No. 14
 1-2-47

FIELD SERVICE BULLETIN

LANDING GEAR CONTROL HANDLE LOCK INSTALLATION

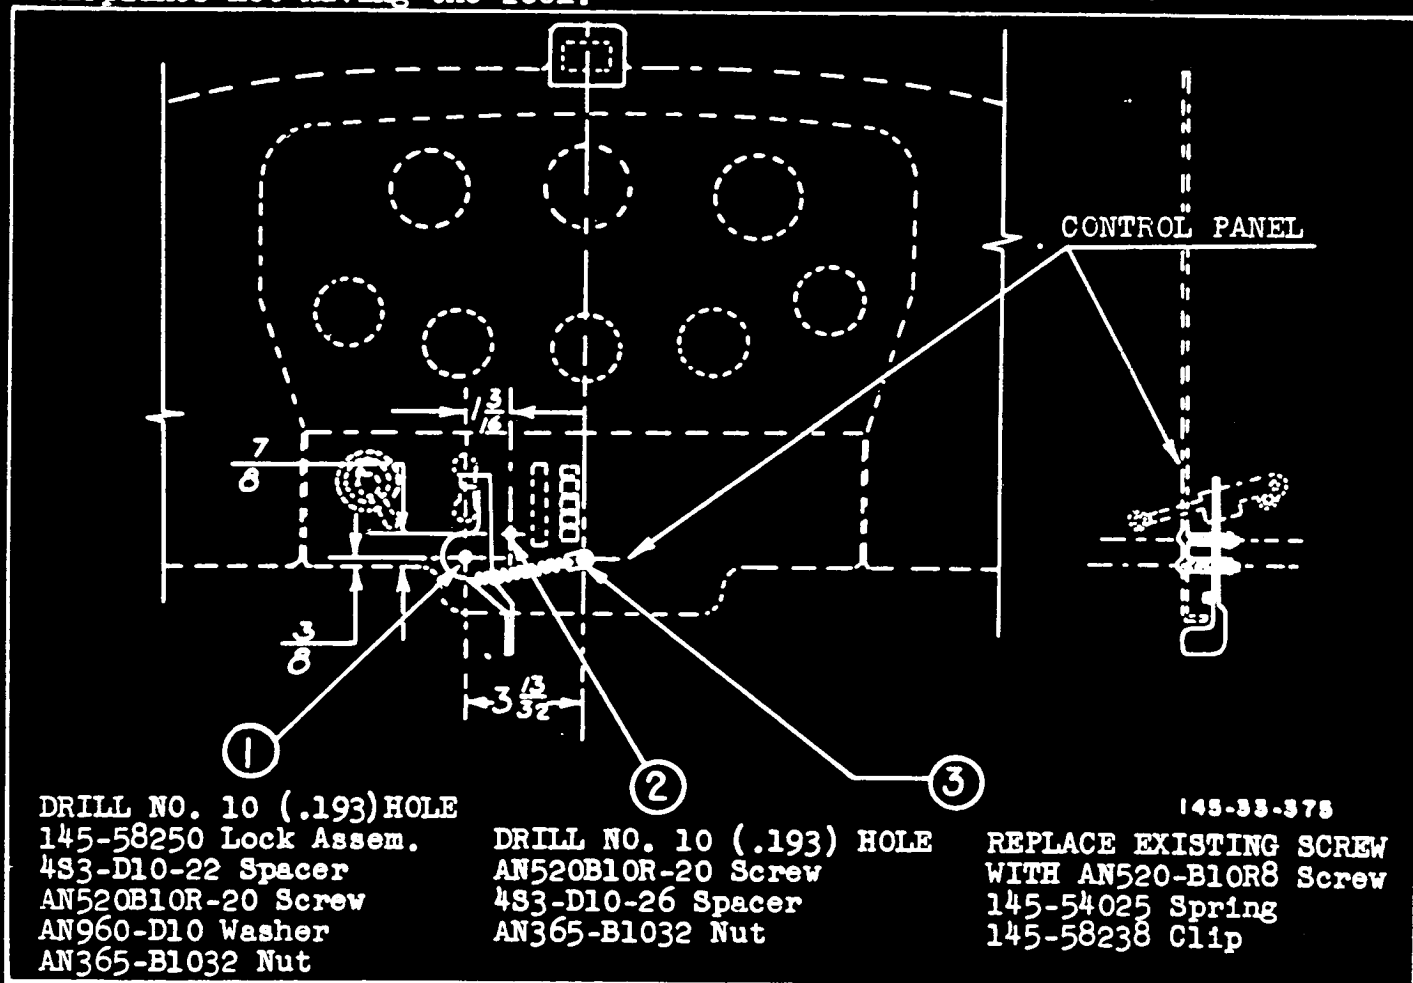
In order to prevent the inadvertent operation of the landing gear control handle, a lock, provided in 145-89015 kit, should be installed as shown, on airplanes not having the lock.

If landing gear control handle lock interferes with hydraulic pump handle, remove handle and open bend to obtain adequate clearance.
